## **Addendum No. 4**

### **South Dade Regional Library Interior Renovations**

**C23-MDPLS-01-ESP**

**ADDENDUM NO. 4**  
16-JAN-2025

### 3.04 ADJUSTING

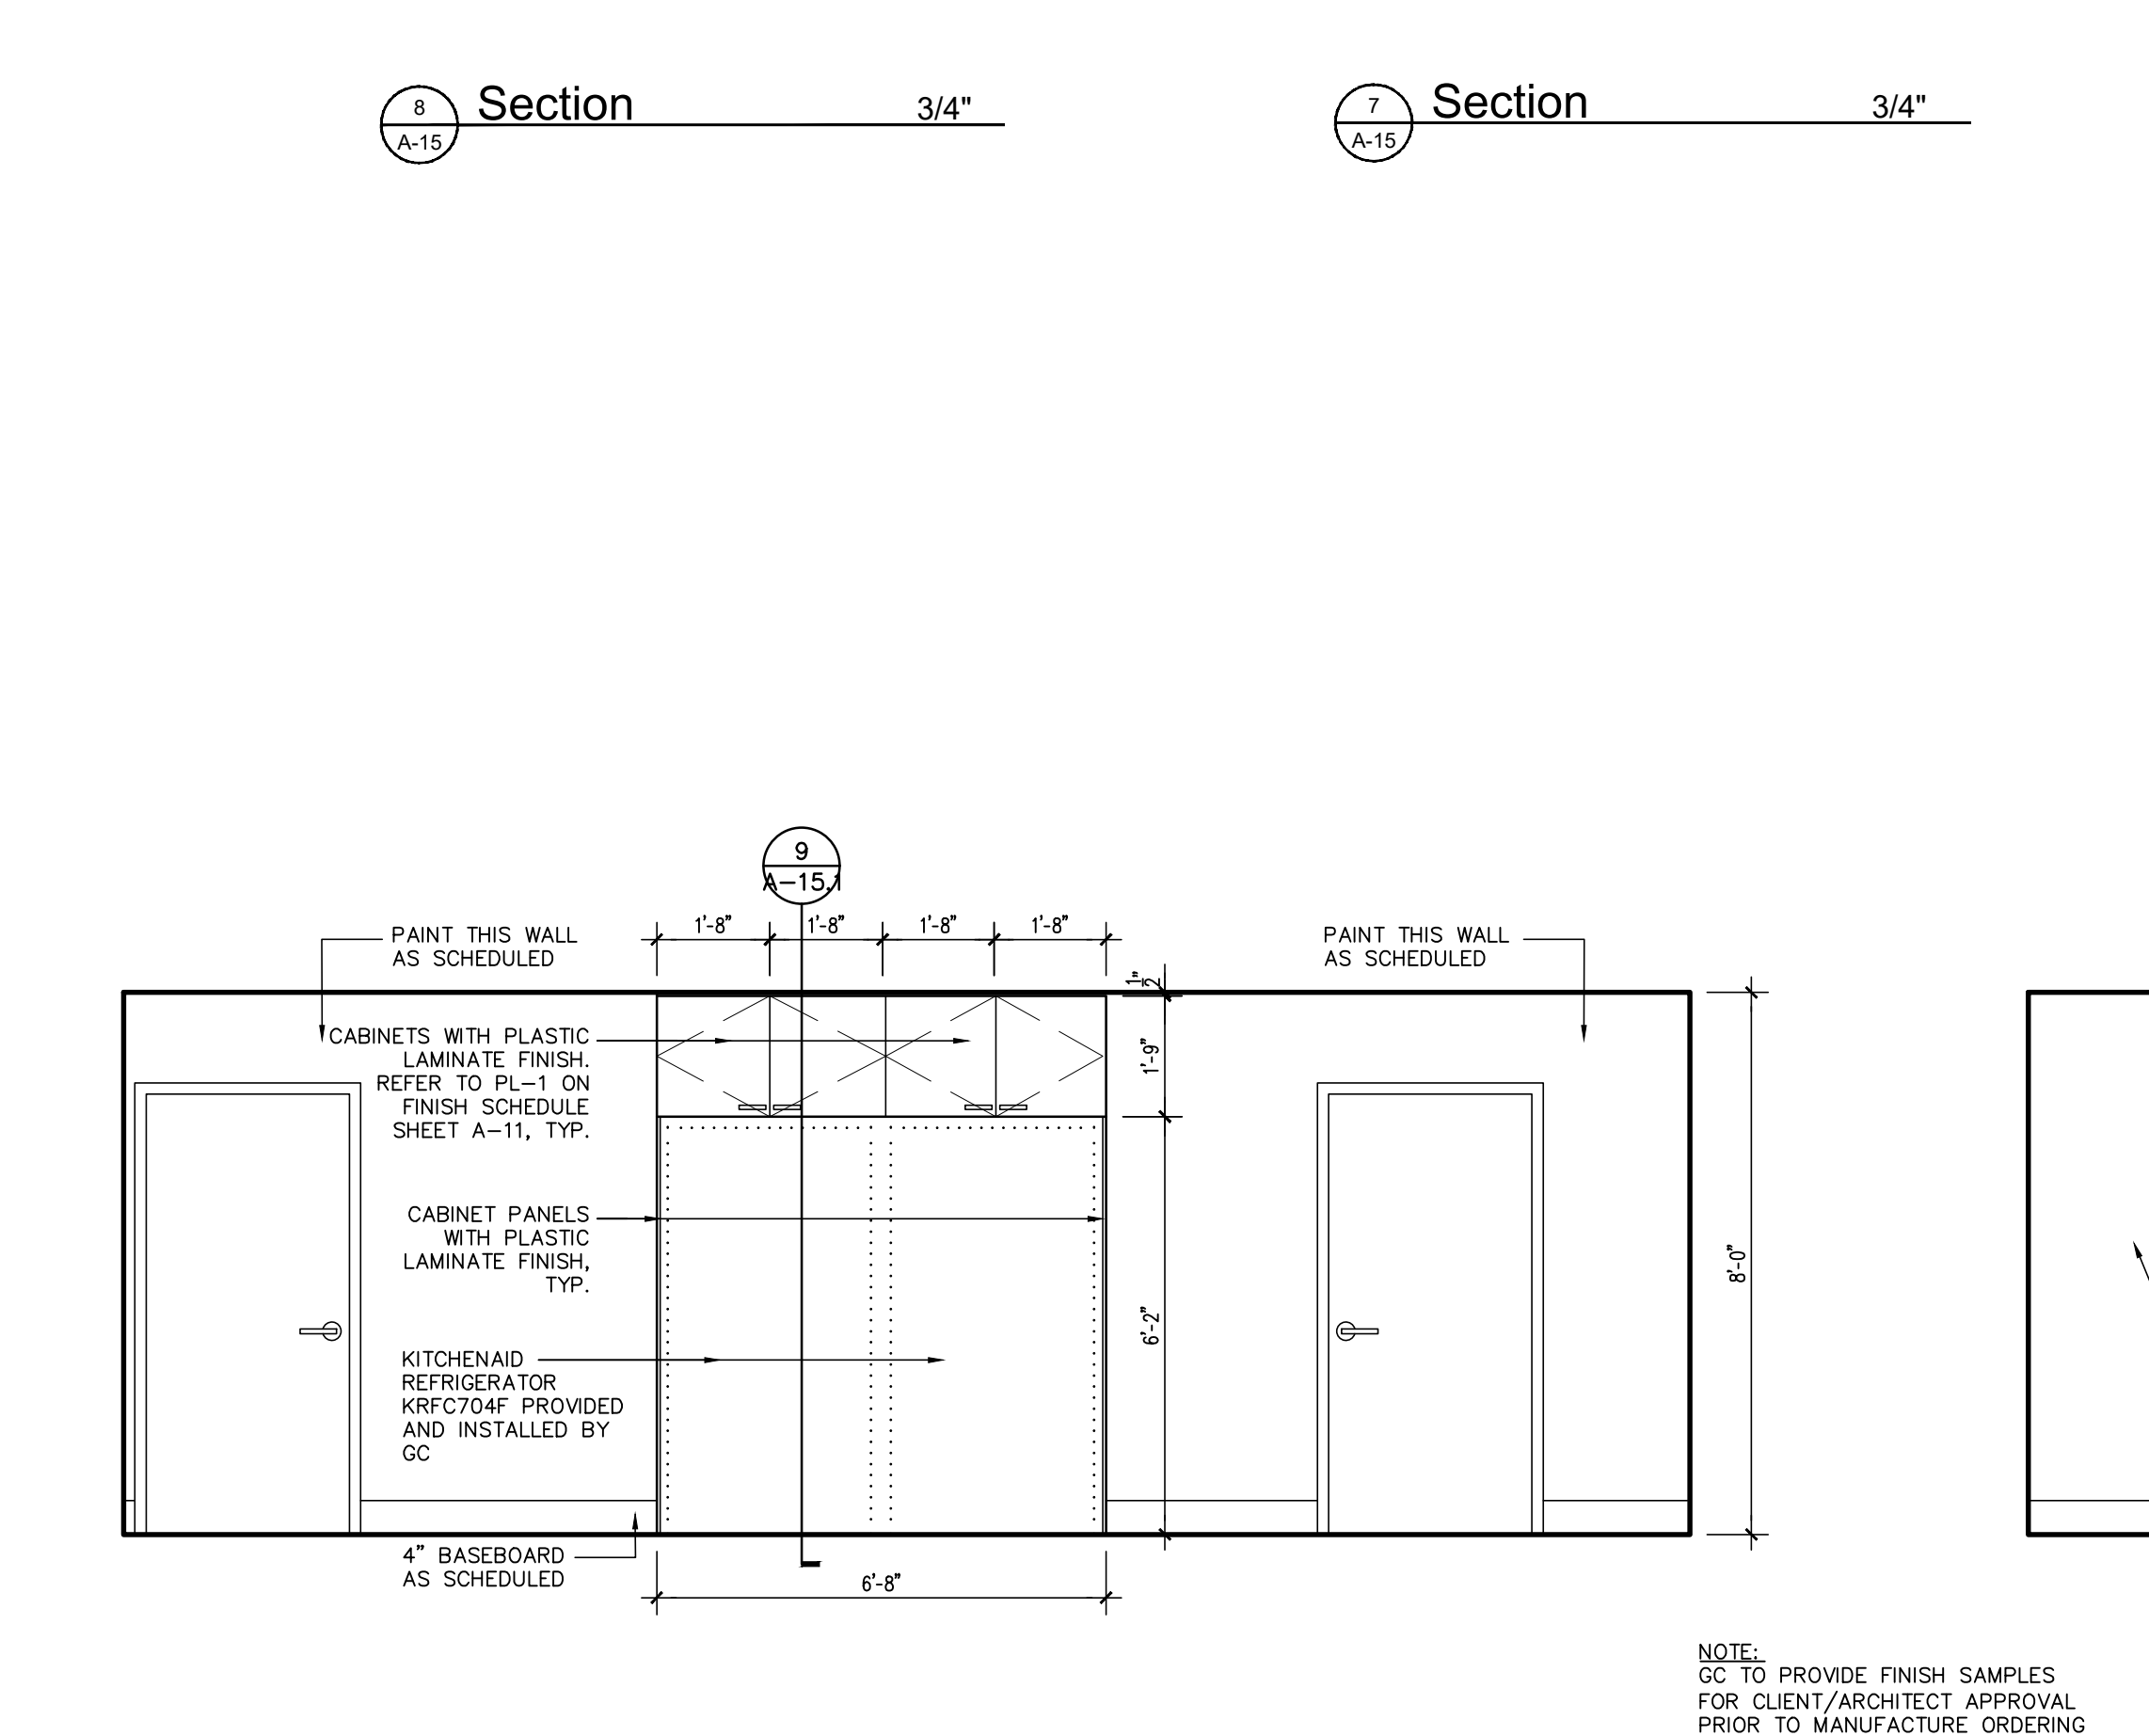
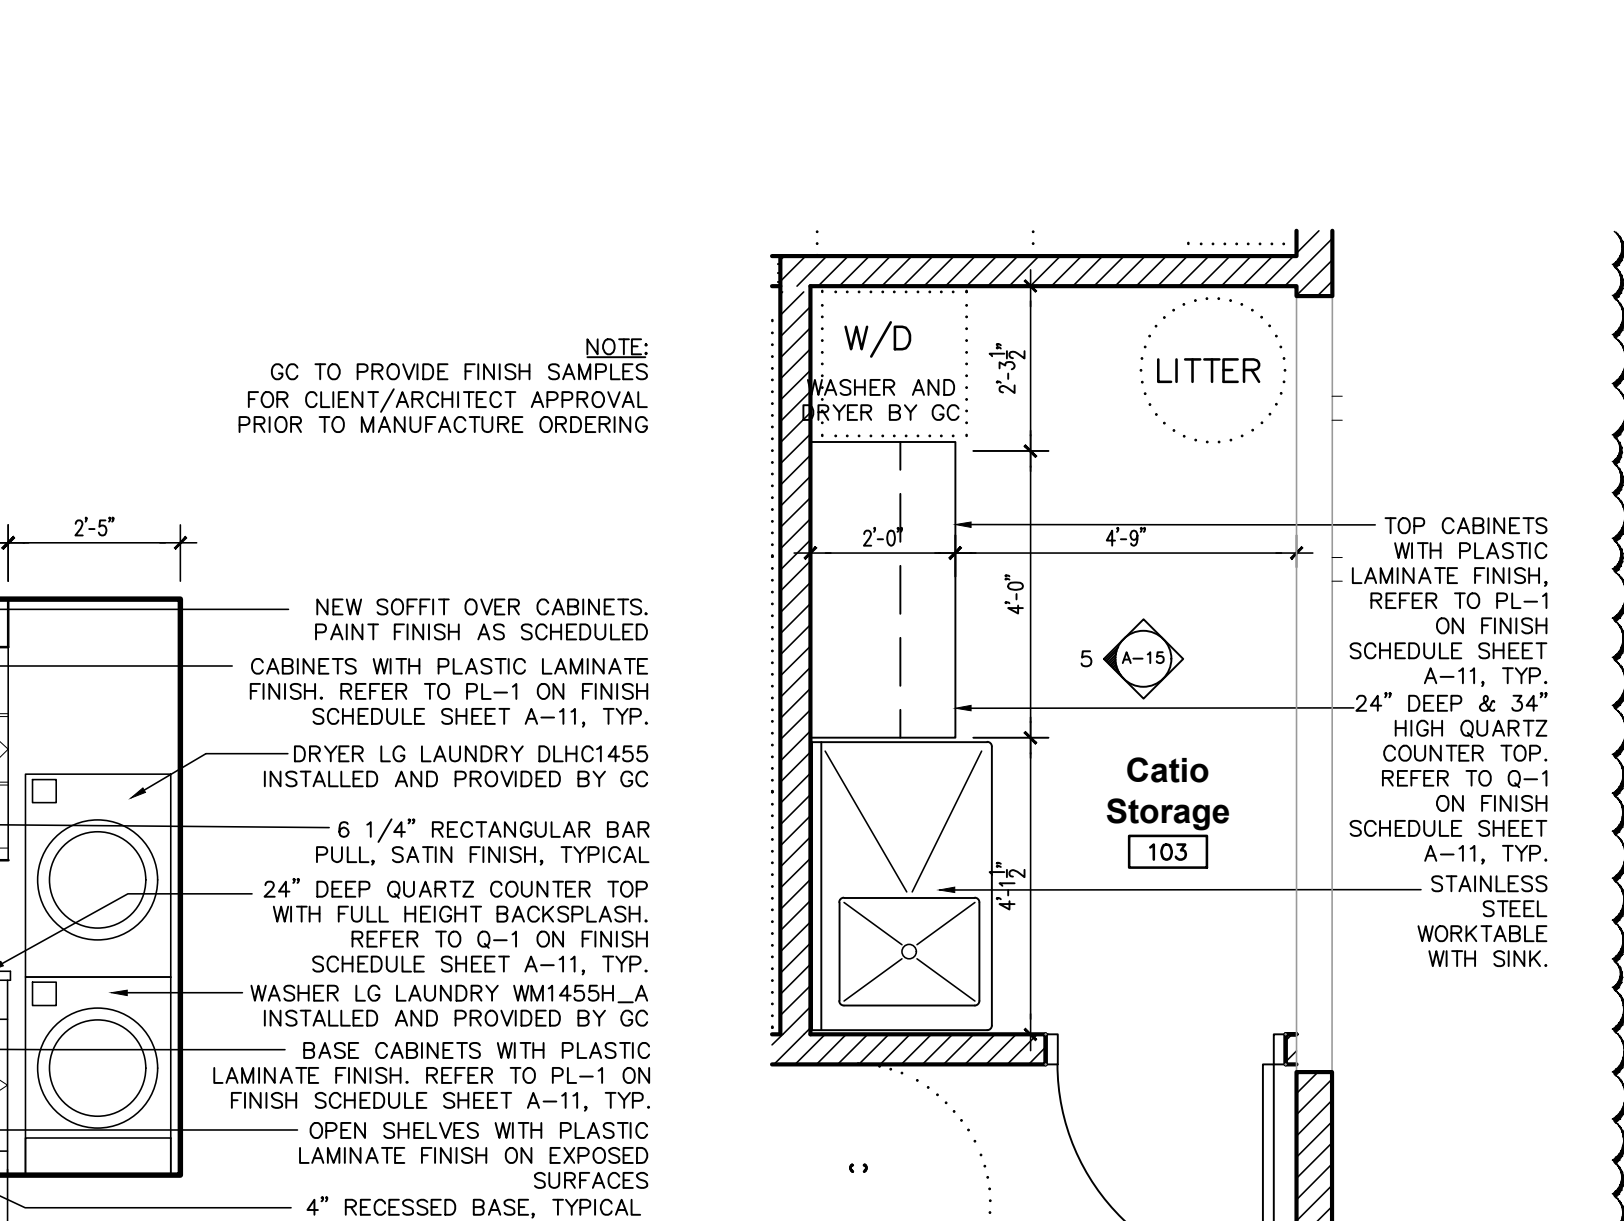
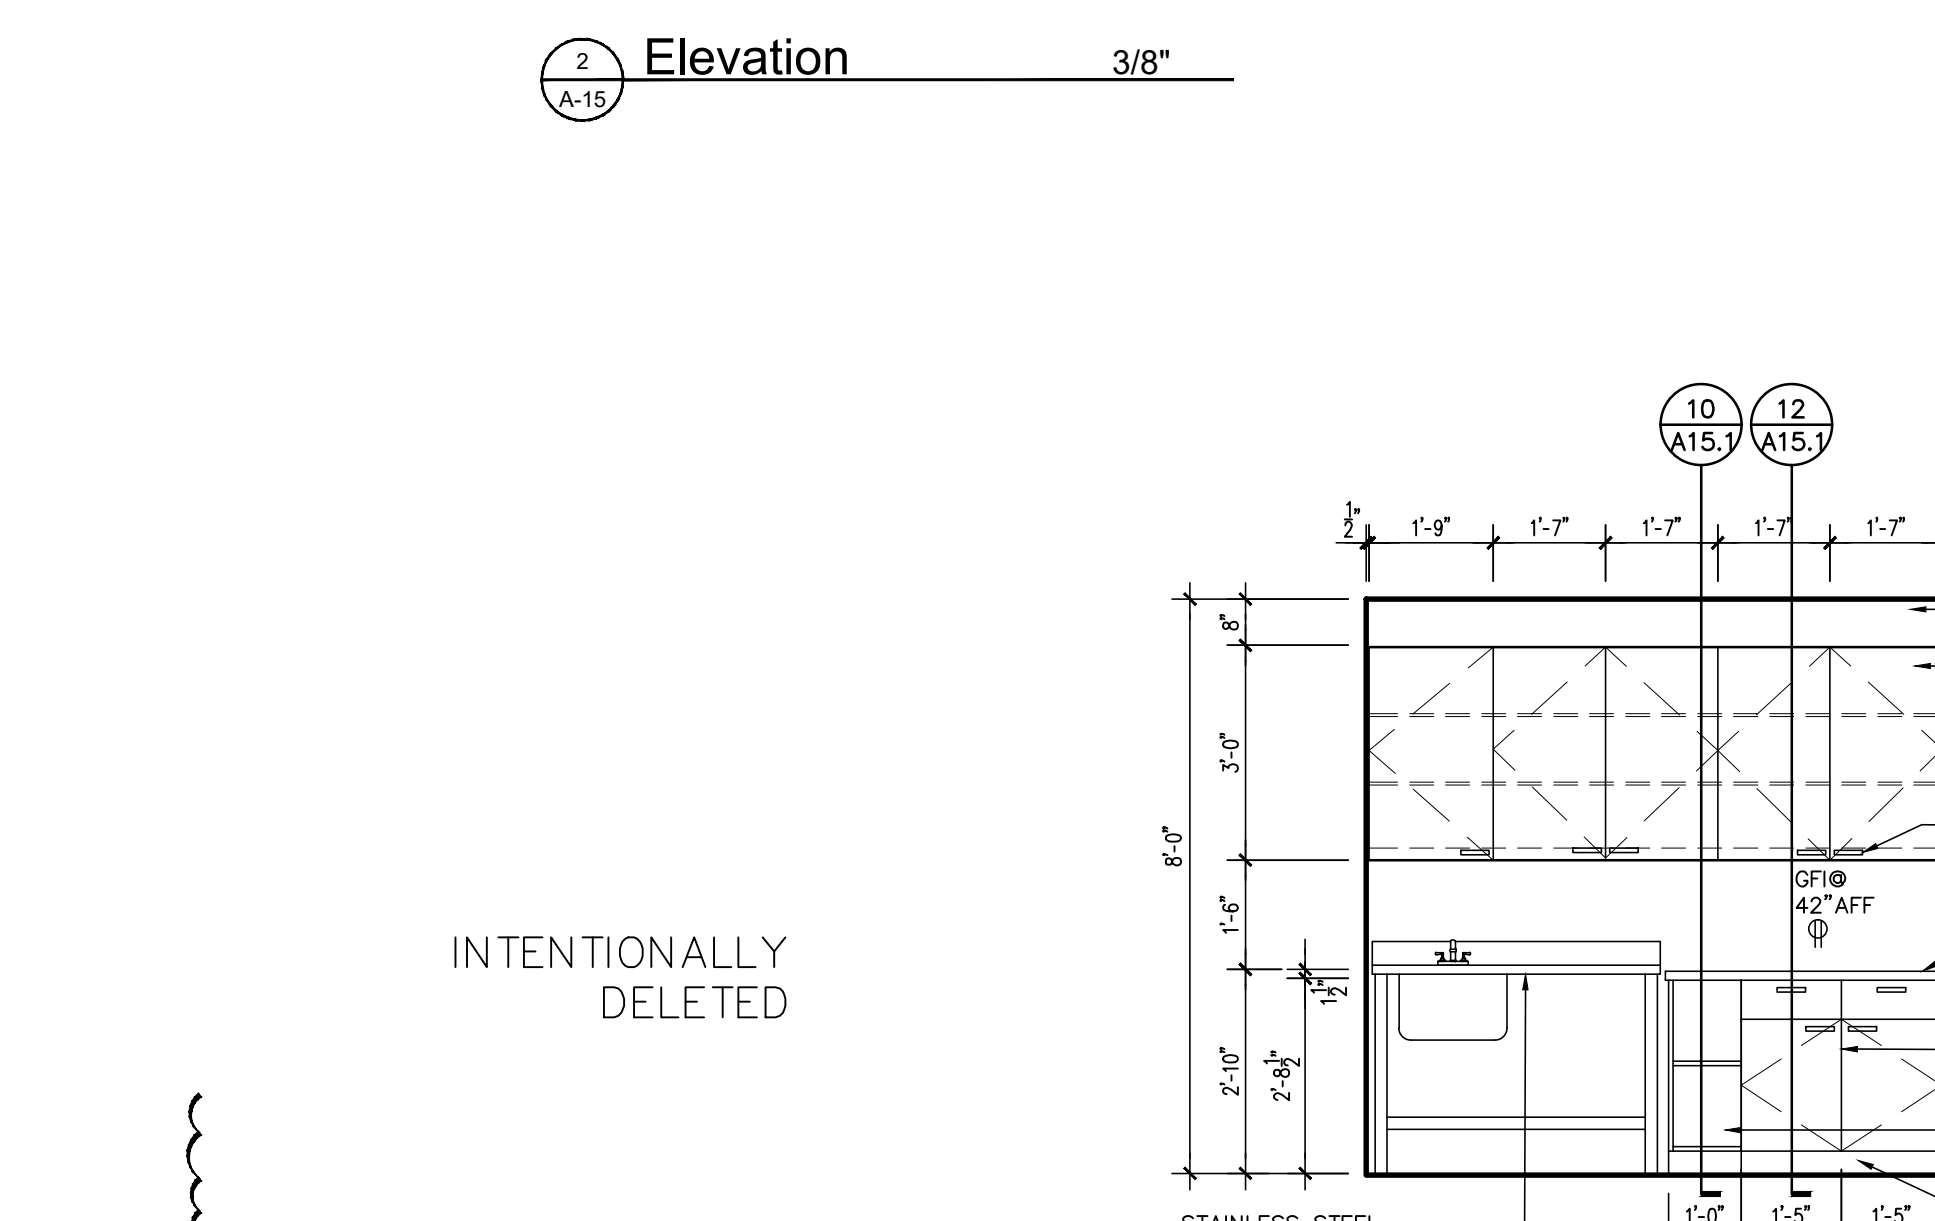
Q60. Plan Sheet A-15 shows a “Grooming Station” at the Catio space, but no manufacturer or model were found. Please clarify if grooming station is to provide and installed by Owner.

**Response Q60: “Grooming Station” refers to a 48”x30” stainless-steel worktable with sink, equal or similar to Uline Model #H-9652L. It should be provided and installed by GC.**

**GC to provide specification sheet for client/architect approval. Refer to revised sheet A-15.**
